ArevaEPRDCPEm Resource

Subject: Response to U.S. EPR Design Certification Application RAI No. 547 (6499, 6359), FSAR Ch. 3 - NEW PHASE 4 RAI, Supplement 5

QUESTIONS for Structural Engineering Branch 2 (ESBWR/ABWR Projects) (SEB2)

Question 03.07.02-78**Open Item****Follow-up to RAI 371, Question 03.07.02-66 and RAI 376 Question 03.08.05-28.**

Figure 3.7.2-78-1: Shell to Solid MPCs for Tendon Gallery and Basemat Connection

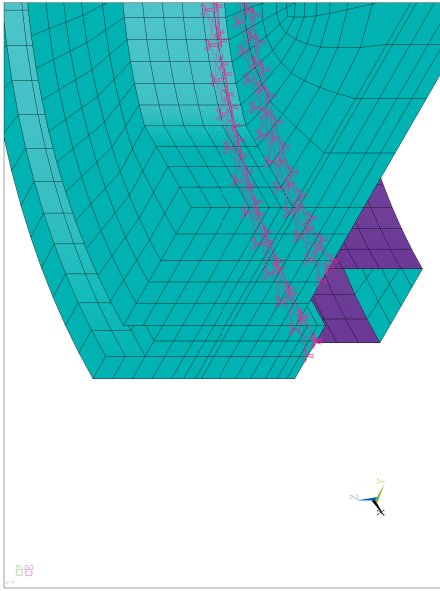
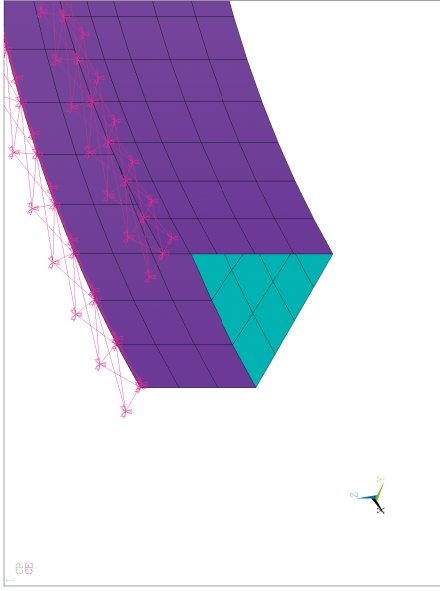
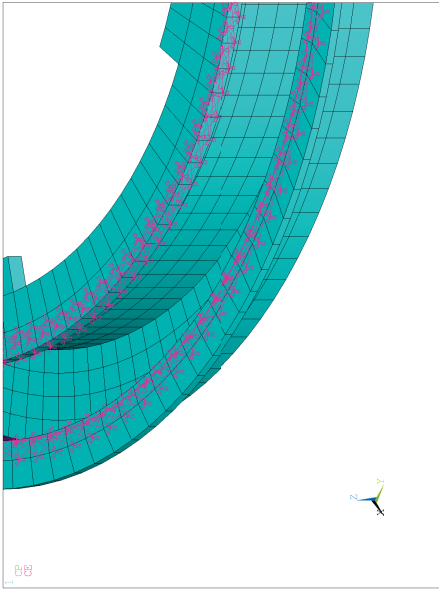
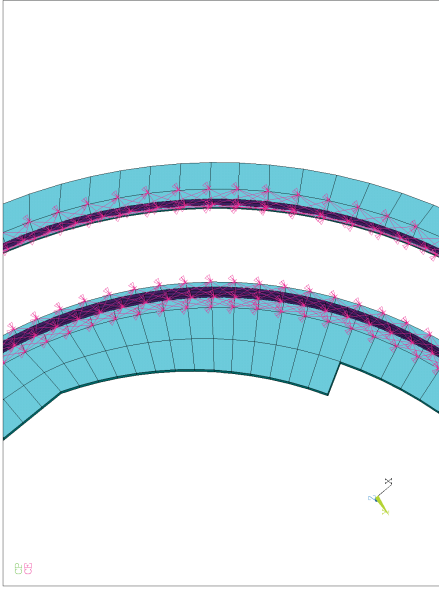
The tendon gallery acts as a shear key under seismic loads. The seismic loads need to include the effect of any localized movement of the basemat. Determining the additional loads due to movement of the basemat is accomplished by performing two separate analyses. In the first analysis, uplift and sliding of the basemat is not allowed. In the second analysis, uplift and sliding is permitted. The difference in the pressure between these two cases is a delta pressure which is added to the lateral loads determined from the SASSI SSI analysis of the NI. For the two rock cases which appear to provide the highest sidewall pressure loads on the shear key, the applicant states that the top ring of nodes of the tendon gallery are connected to the solid element basemat using ANSYS shell to solid Multi-Point Constraints (MPCs) and have no sidewall rock springs. The bottom ring (elevation) of nodes of these shell elements that are connected to the basemat have stiff sidewall rock springs that simulate partially fixed boundary conditions. These nodes experience higher pressures and moments (stress concentration effect) typically associated with fixity. For these cases, average maximum pressure values considering a full element instead of a node are presented in Table 03.07.02-66-2. As it is not clear from the applicant's explanation which nodes or elements are being described and what is meant by partially fixed boundary conditions, the applicant is requested to provide:

- A figure depicting the boundary conditions for the shear key nodes and;
 - A figure depicting maximum pressure values and average pressure values over the complete height of the tendon gallery with a description of how the average values were calculated.

- The TG walls are modeled using shell elements (ANSYS SHELL43 elements) and connected to the solid element basemat (ANSYS SOLID45 elements) using ANSYS shell to solid Multi-Point Constraints (MPCs). Figure 3.7.2-78-1 shows the shell to solid MPCs. The bottom of the NI basemat solid elements is located at different elevations. The outer TG walls connect to the Balance of Nuclear Island portion of the NI common basemat at elevation -41ft and the inner TG walls connect to the RBIS/RCB portion of the NI common basemat at elevation -36 ft. Table 3.7.2-78-8 lists the nodes at different elevations of the TG and their boundary conditions.

Figure 3.7.2-78-7: SSI Pressure with and without scaling for Wall 2, Soil Case 1n2ue

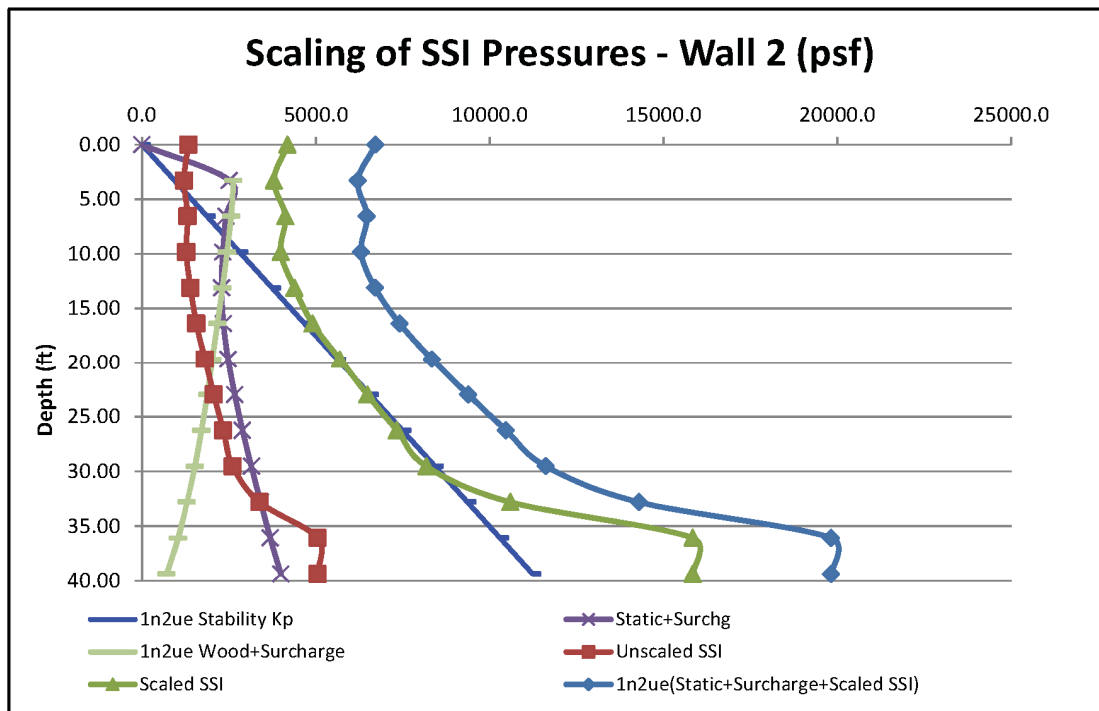
- (b) Provide a graphical explanation of the scaling of the SSI pressure profiles. Clarify whether this scaling is done at each depth so that the scaled SSI pressure profiles always bound the linear $K_p=3.0$ pressure profile, or whether the scaling is done at one depth only using a single scaling factor applied to the entire profile. (It is stated that the maximum pressure on each wall is at least equal to the passive earth pressure of $K_p=3.0$).

- (b) .Figure 3.7.2-78-7 illustrates the scaling of SSI pressures for a typical wall (Wall 2) and soil case (1n2ue). The scale factor for a given soil case corresponds to the ratio of the maximum passive pressure to the maximum SSI pressure along the depth of the embedded wall. The (single) scale factor is applied to the SSI pressure profile (along the depth of a wall) for a given soil profile. For Wall 2 with soil case 1n2ue, the maximum SSI pressure (at depth of -38.9 ft) is 5,054 psf, and the maximum passive pressure at this depth is 15,835 psf. The scale factor is calculated as 3.13. This scale factor is applied to the SSI pressures (labeled “Unscaled SSI”) at various depths to arrive at the scaled SSI pressures (labeled “Scaled SSI”).

Figure 3.7.2-78-8: Wall 2 - Soil 1n2ue & 1n5aeh (Cracked Concrete Case)

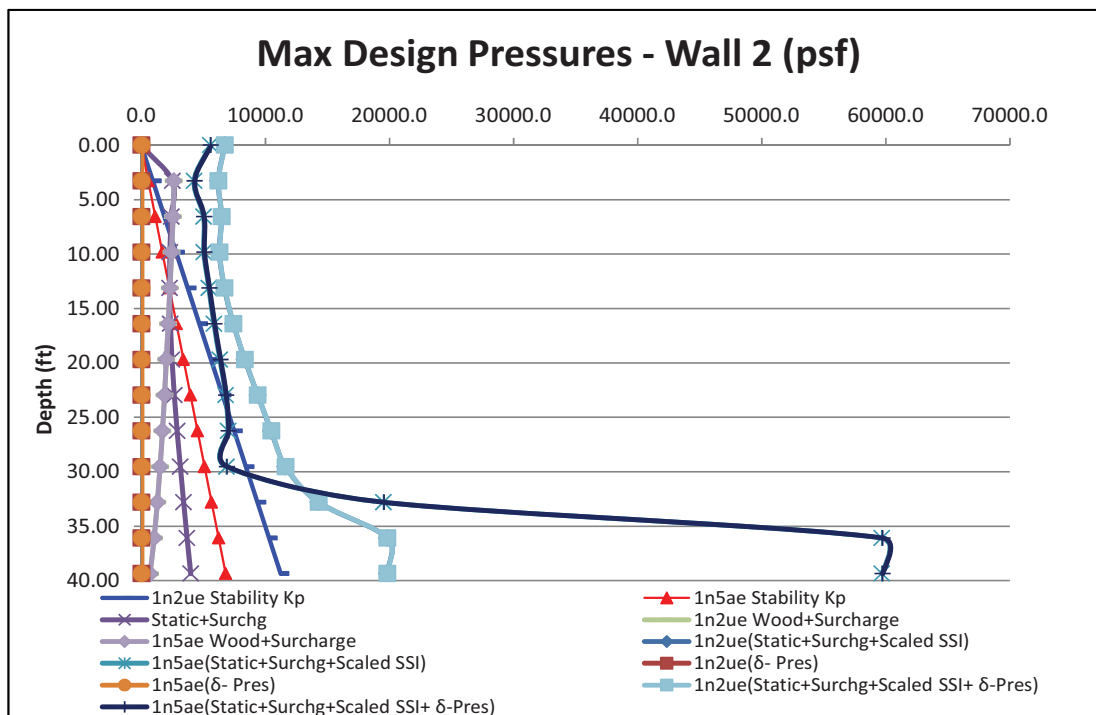
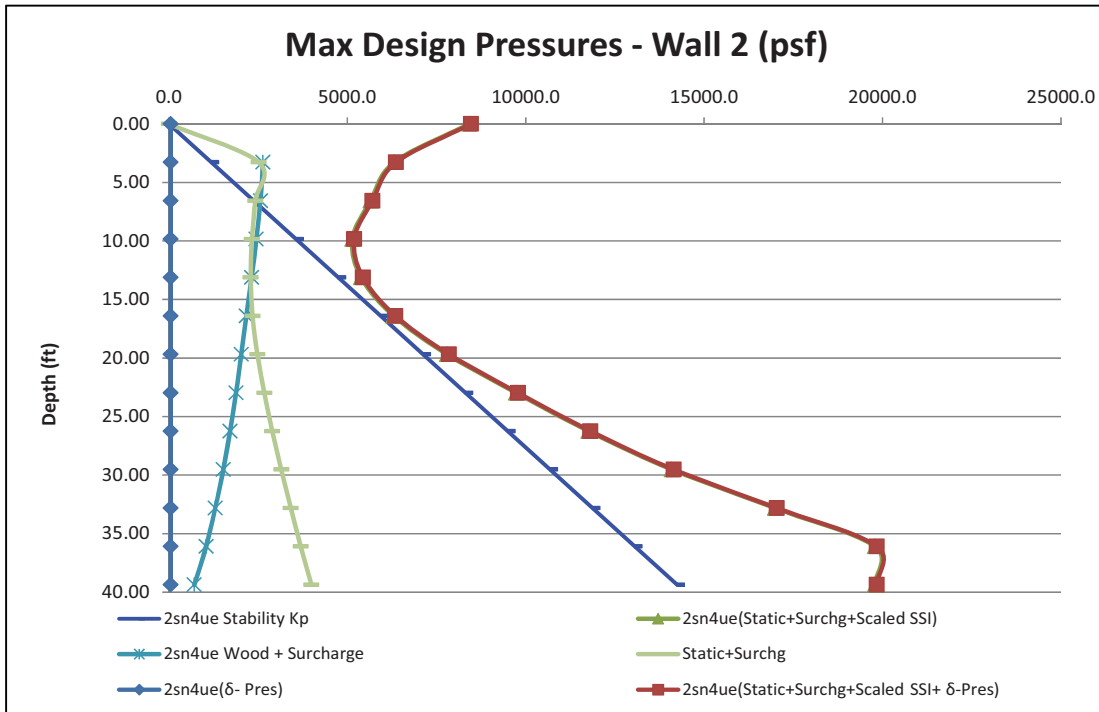
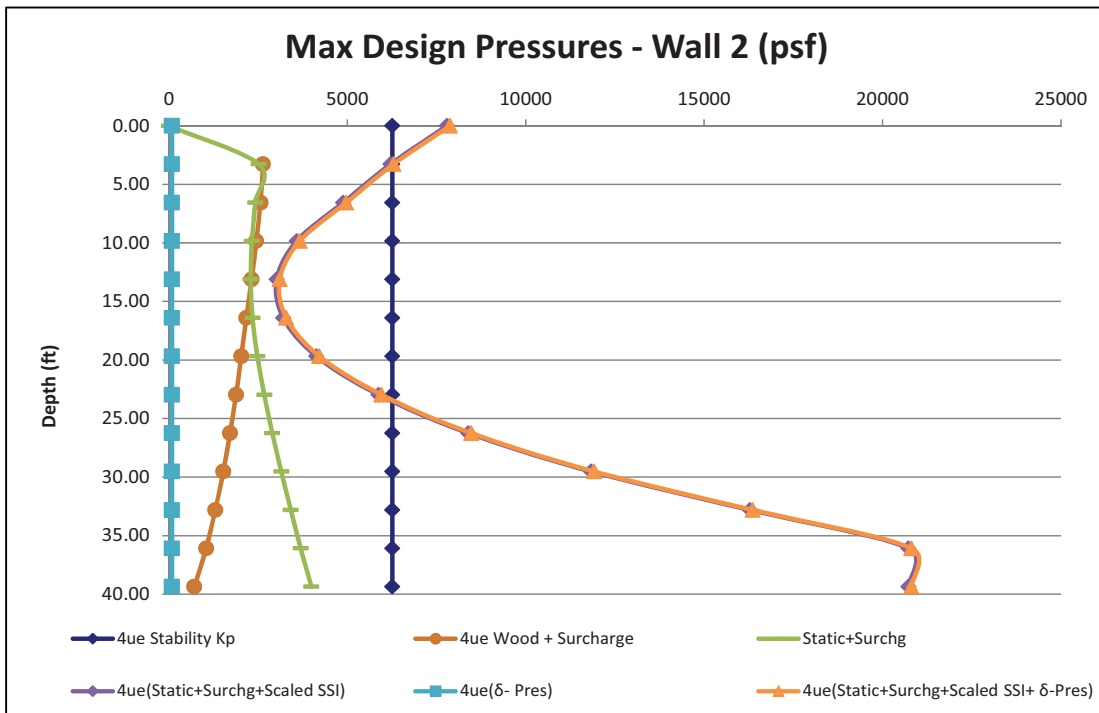
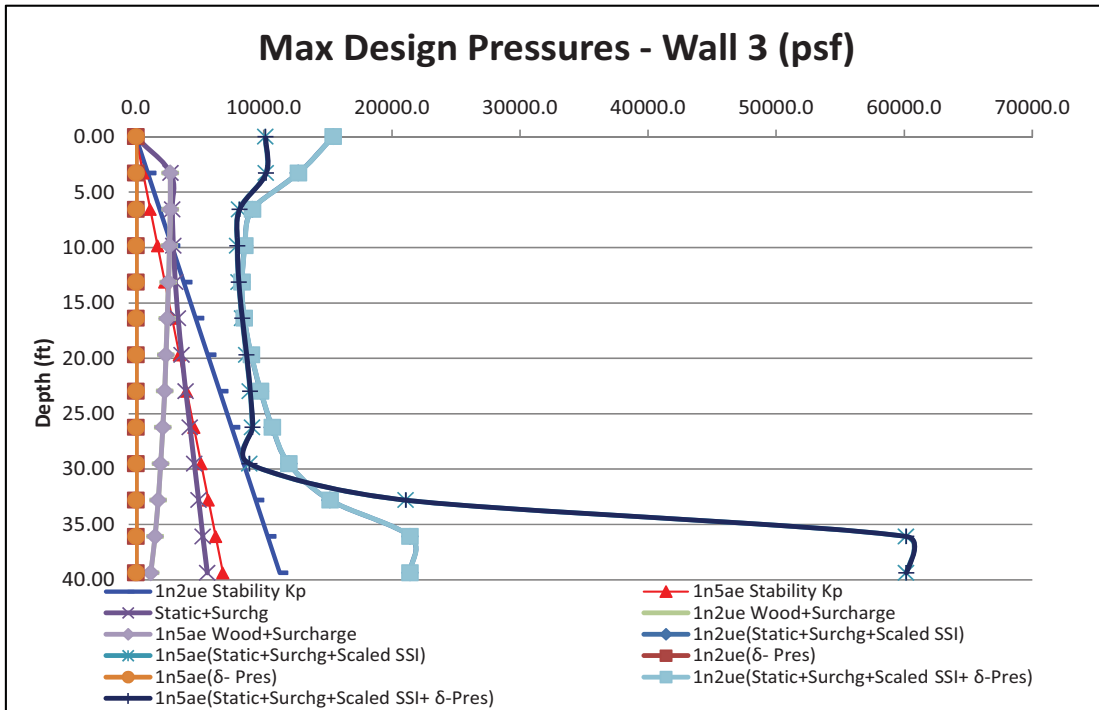
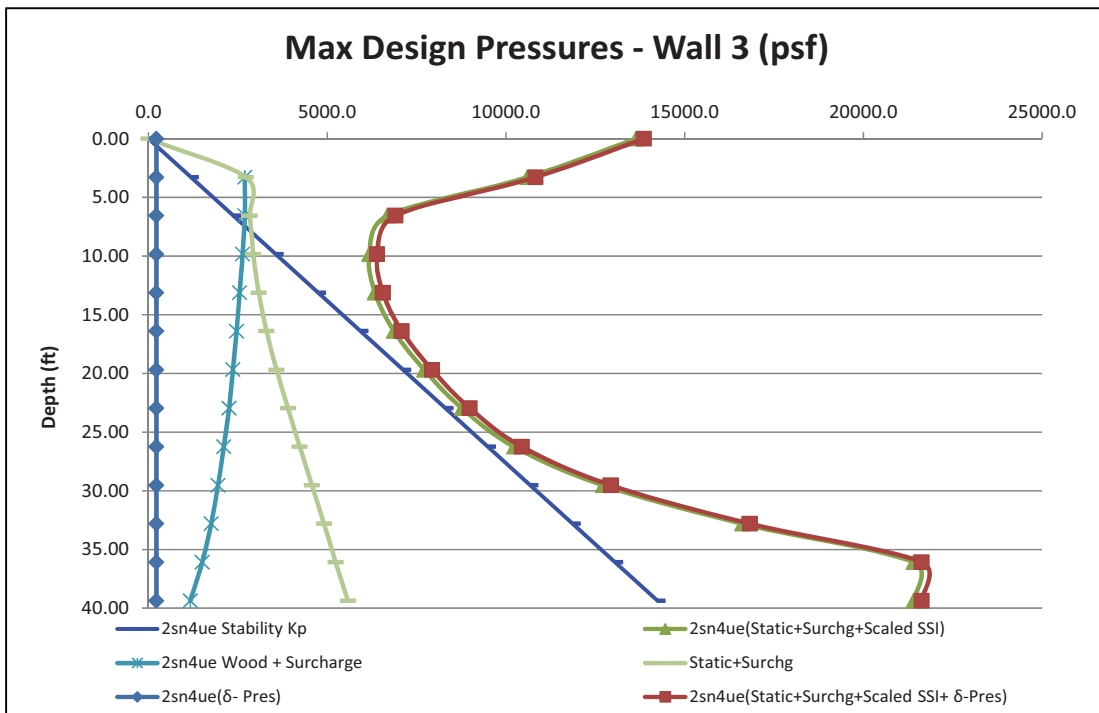
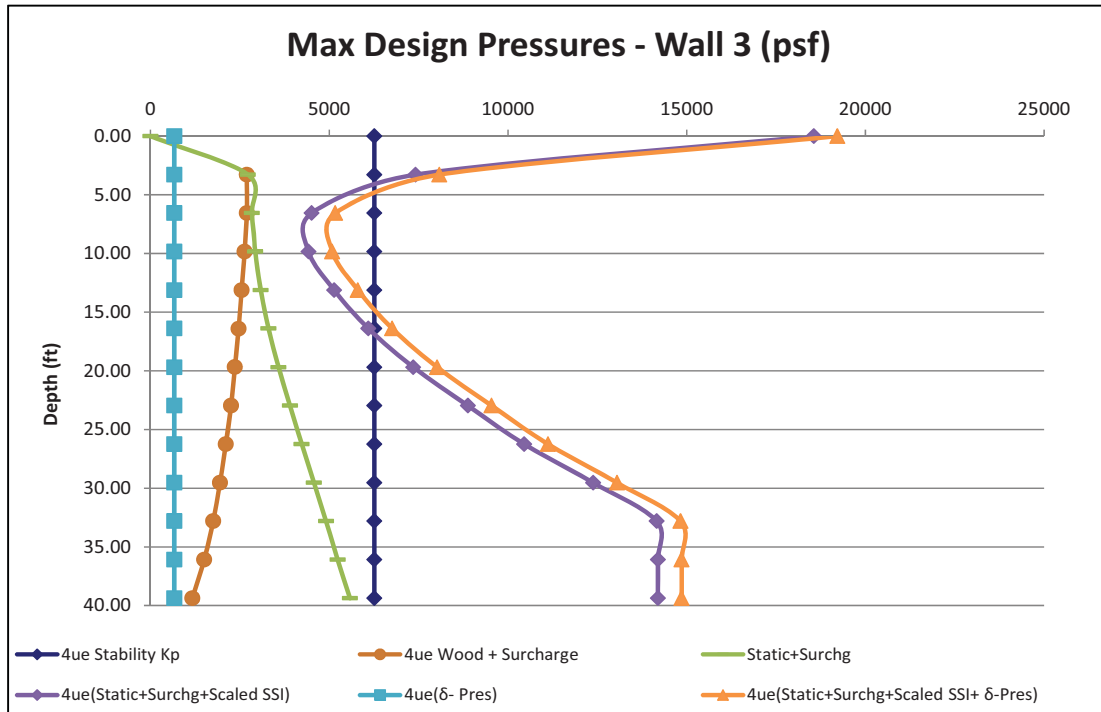
- (c) A review of the referenced figures indicates that, for a given wall, soil, and analysis case, it does not appear to be always true that the scaled SSI pressure profile always bounds the pressures required by the sliding stability analysis. For example, in Figure 03.08.05-28-5 (Wall 2, "cracked" analysis) the vertical "4uem Stability K_p " profile (blue line) is greater than the "4uem" profile (magenta line) at depths between approx. 5 ft. and 25 ft. A similar situation is observed in Figure 03.08.05-28-61 (Wall 2, "uncracked" analysis). This is due to the difference in the relative shape of the two pressure profiles. Since the applicant indicates that it is not using an envelope of all soil cases (such as the ones shown in Figures 03.08.05-28-42 through 03.08.05-28-59 and Figures 03.08.05-28-98 through 03.08.05-28-115), but is considering each soil case independently, explain how

- (c) The combined static, surcharge, delta pressure, and scaled SSI pressures generally bound the pressures required by the sliding stability analysis (SSI analysis). The example cited in the Response to RAI 376, Question 03.08.05-28, corresponds to the soil case 4uem for which a uniform soil pressure of 43.5 psi for the walls and 50 psi for the TG was applied to provide the minimum factor of safety for sliding. Note that for soil case 4uem, the scaled SSI pressure with static, surcharge and delta pressures do not bound the stability pressure case at certain local sections of the wall (between roughly 5 ft. and 25 ft. from the top). However, Figure 3.7.2-78-46 through Figure 3.7.2-78-55 show that other soil cases would govern the design of the walls; and, in fact, exceed the stability pressure requirements of soil case 4uem. In soil case 2sn4uem for walls 5 and 11, only minor sections of the wall were not bounded by the scaled pressures. However, the design of the wall would be governed by the larger sidewall pressures at the top and bottom of the walls where the scaled SSI pressures are significantly greater than the stability pressures.

- (d) Figure 3.7.2-78-8 through Figure 3.7.2-78-37 show the stability (K_p); static and surcharge; Wood's and surcharge; static, surcharge, scaled SSI and additional (delta) pressure due to localized sliding/uplift of the basement; and the combined delta pressure, scaled SSI, static and surcharge for the embedded walls.

Figure 3.7.2-78-56—Bearing Pressure Distribution for Foundations

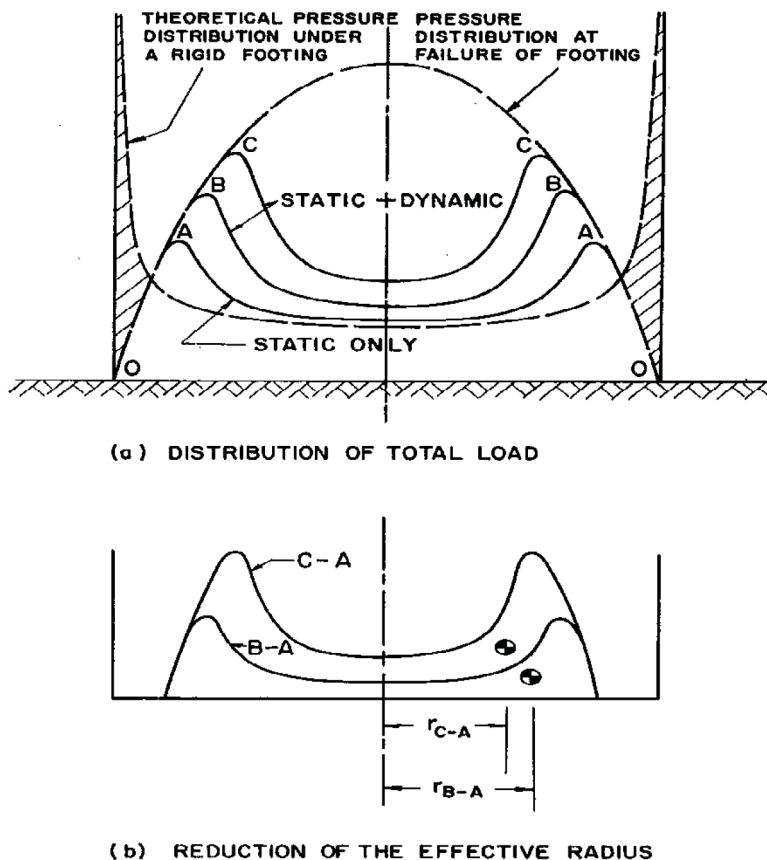
- (b) For the bearing pressure contour plots shown in Figures 3.8.5-28-A through 3.8.5-28-D, provide the technical basis for the process used to average the corner pressures, toe pressures, and any other localized pressure “hotspots.”

- (b) As reported in technical literature (see F.E. Richart and R.V. Whitman, "Footing Vibrations – Comparison of Test Results with Theory," University of Michigan, IP-755, November 1966) theoretical equations result in very high bearing pressures near the edges of the footing due to singularity. The authors present a more credible bearing (failure) pressure distribution shown in Figure 3.7.2-78-56 (reproduced from Richart's paper). In accordance with the postulated pressure distribution for combined static and dynamic loads, the bearing failure point moves away from the edge of the footing. Though the paper does not provide specific guidelines for averaging pressures near the edges (and corners), it does point to the need for a more realistic treatment of the theoretically derived peak pressures near the edges; and, thus, any FEM analysis. Therefore, averaging of the bearing pressures over the corner and edges of the basemat is considered to be a reasonable approach to estimate the corner and edge pressures.

Figure 3.7.2-78-57: Case 1n2ue, Cracked, Time Snapshot of the Dynamic Bearing Pressure at Max Dynamic Bearing Pressure Time(s)

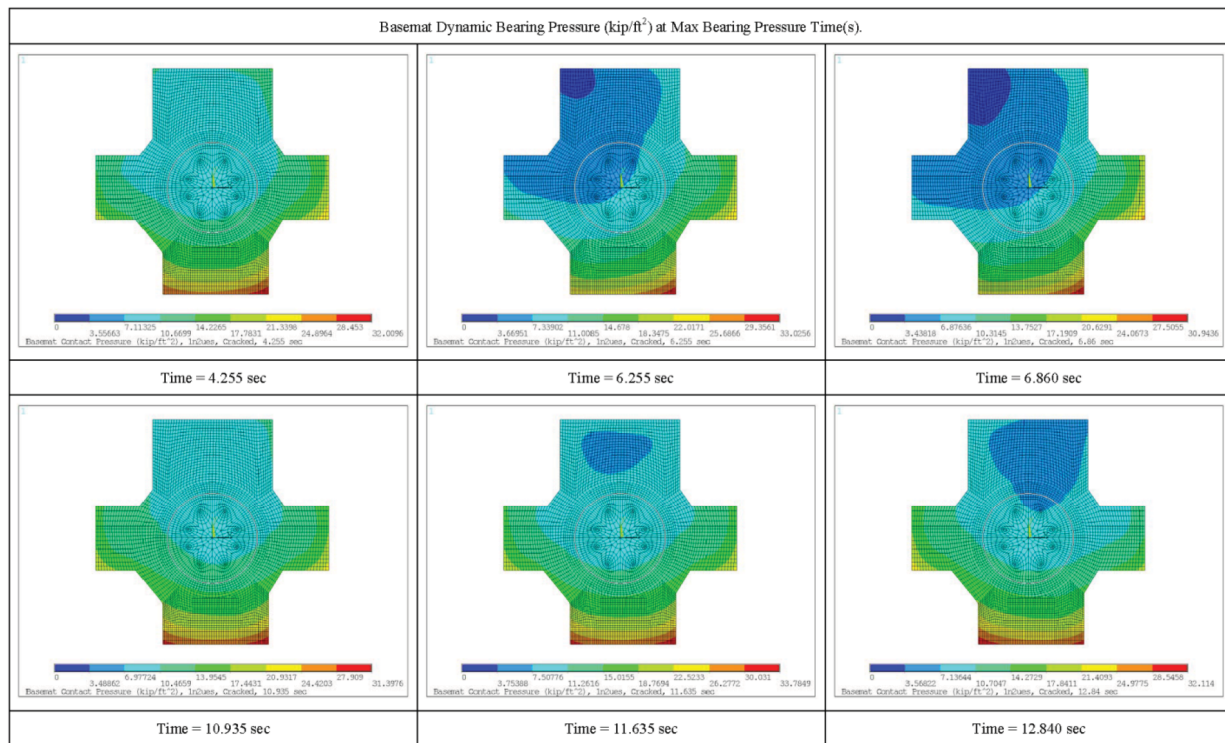
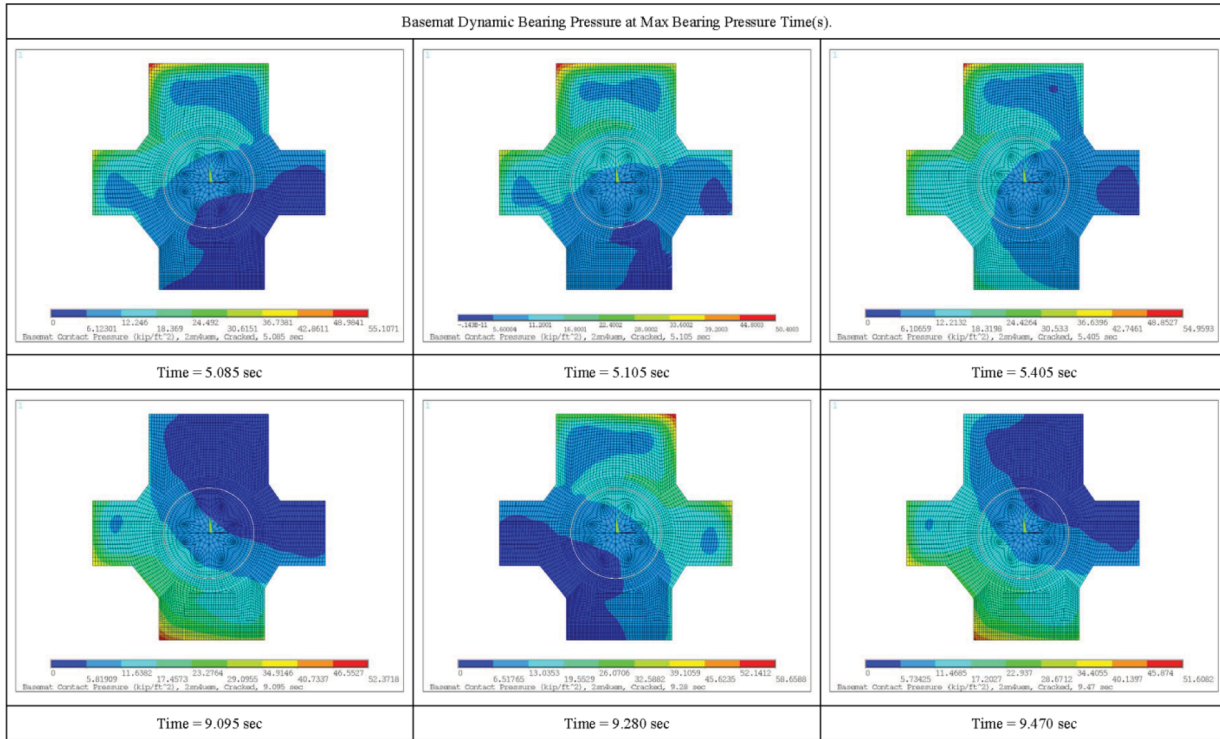
- (d) Item 5(e) of the RAI response indicates that the ANSYS 3D FEM basemat model results were compared to the SASSI FEM model results. Since the reported bearing pressures are obtained from the SASSI FEM model results, provide bearing pressure contour plots similar to those in Figures 3.8.5-28-A through 3.8.5-28-D, obtained from the ANSYS 3D FEM basemat model. Discuss the comparison between the two sets of results.

- (d) Bearing pressure contour plots generated from the ANSYS 3D FEM basemat model are shown in Figure 3.7.2-78-57 through Figure 3.7.2-78-60. These contour plots correspond to soil cases 1n2ue, 2sn4uem, 4uem, and 5aeh, respectively; and correspond to the SASSI-generated contour plots with similar soil cases shown in Figure 3.8.5-28-A through Figure 3.8.5-28-D in the Response to RAI 376, Question 03.08.05-28. The contour plots shown for the ANSYS results represent the bearing pressures without any averaging, whereas the SASSI contour plots show averaged corner and edge pressures. The two sets of results are comparable.
